WOODBURY COUNTY BOARD OF SUPERVISORS AGENDA ITEM(S) REQUEST FORM

WORDING FOR AGENDA ITEM: Old Lakeport Rd cul-de-sac Residents Access to their homes during construction of the Elk Creek Rd paving and Round-About. ACTION REQUIRED:				
Public Hearing	Other: Informational 🗹	Attachments ☑		
EXECUTIVE SUMMARY:				
ACKGROUND:				
ACKOROSKE.				
AGRICAGOND.				
ACKOROSKID.				
INANCIAL IMPACT:				
INANCIAL IMPACT:				
INANCIAL IMPACT: THERE IS A CONTRACT INVOLVE	D IN THE AGENDA ITEM, HAS THE C	ONTRACT BEEN SUBMITTED AT LEAST ON	NE WEE	
INANCIAL IMPACT: THERE IS A CONTRACT INVOLVE RIOR AND ANSWERED WITH A RE			NE WEE	
INANCIAL IMPACT: THERE IS A CONTRACT INVOLVE RIOR AND ANSWERED WITH A RE			NE WEE	
INANCIAL IMPACT: THERE IS A CONTRACT INVOLVE RIOR AND ANSWERED WITH A RE			NE WEE	
INANCIAL IMPACT: THERE IS A CONTRACT INVOLVE RIOR AND ANSWERED WITH A RE			NE WEE	
INANCIAL IMPACT: THERE IS A CONTRACT INVOLVE RIOR AND ANSWERED WITH A RE			NE WEE	
INANCIAL IMPACT: THERE IS A CONTRACT INVOLVE RIOR AND ANSWERED WITH A RE			NE WEE

RE: Elk Creek Road Construction Project

ELK CREEK ROAD CONSTRUCTION OLD LAKEPORT RD TO N. OF SINGING HILLS BLVD, SIOUX CITY, IOWA

Sheet H.01

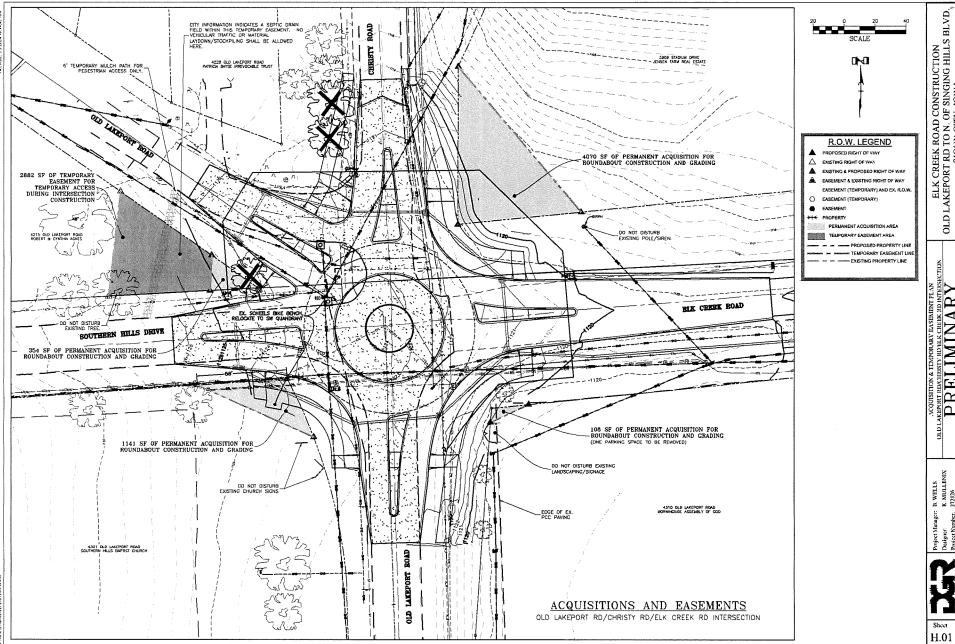
- 1. The City understands a septic tank and leech field is in the proposed temporary easement.
- 2. A temporary access path shown in the easement area for the use of the residents on Old Lakeport Road to the north-west of the intersection is attached.

- 3. The temporary access path will be a wood mulch path maintained by the contractor during construction. No vehicle traffic will be allowed on this mulch path.

- The wood mulch path will be for <u>foot traffic only</u> and will prevent damage to the leech field.
 - The wood mulch path will be reduced in width to avoid your mailbox and landscaped area on Old Lakeport Road.

- The City will have notes added to the plans that the Contractor will NOT drive vehicles in and will NOT store materials or vehicles in the temporary easement area.

- 4. The tree in the temporary easement area by Southern Hills Drive will not be removed as part of the project.
- 5. Restoration of the temporary easement area will comply with our standard construction specifications. The requirements are provided below:

Round-About (RJA Alt. Access Rd.).pdf

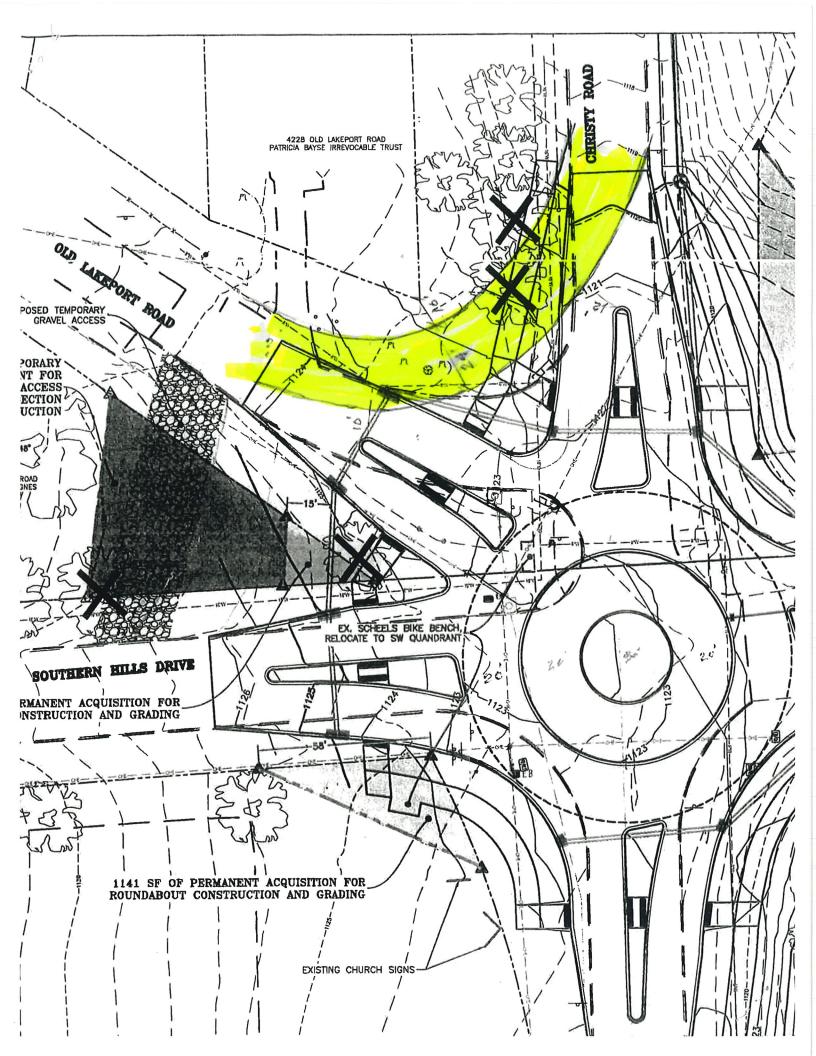
See attached sketch for my thought on a possible alternative access road.

This would require the paving of both the east portion of Christy Rd. and the north portion of Old Lakeport Rd cul-de-sac while the temporary access road remains in use. The divider islands on each of those roads could be partially constructed to control traffic. Then use both those newly paved single lanes until the access road could be removed and street (and islands) pavement completed. Note: it would still involve some replacement of landscaping which now exists at the location of the temporary access road, but hopefully not infringe on the Basye property nor require any more trees along Christy Rd. to be removed than are shown on DGR's 8/30/23 preliminary plan. I should be available this Friday for a meeting if you want to schedule such.

LANE CLOSURE ON LOW VOLUME STREET (SELF-REGULATING)

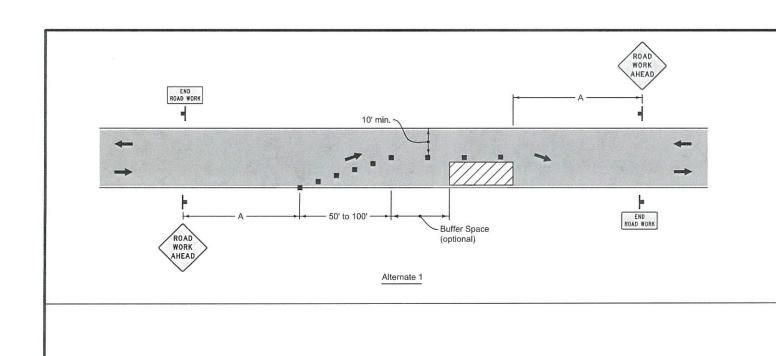
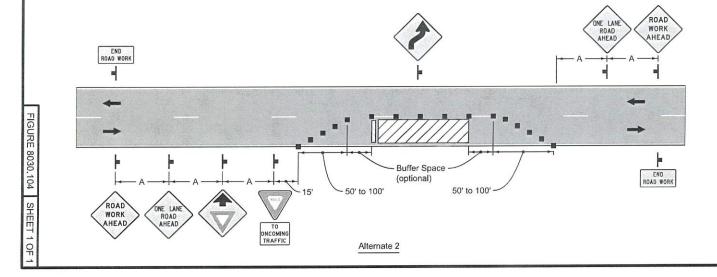
As you can see in the SUDAS diagram in the scan above, accepted traffic control standards for two way traffic only require a 10 foot wide lane for navigating around a lane closure. The plan sheet included in page one of the attached .pdf shows that we are building the temporary road 18' wide. This should be plenty of room for two vehicles to navigate the opening, either at the same time or with one waiting while the other passes.
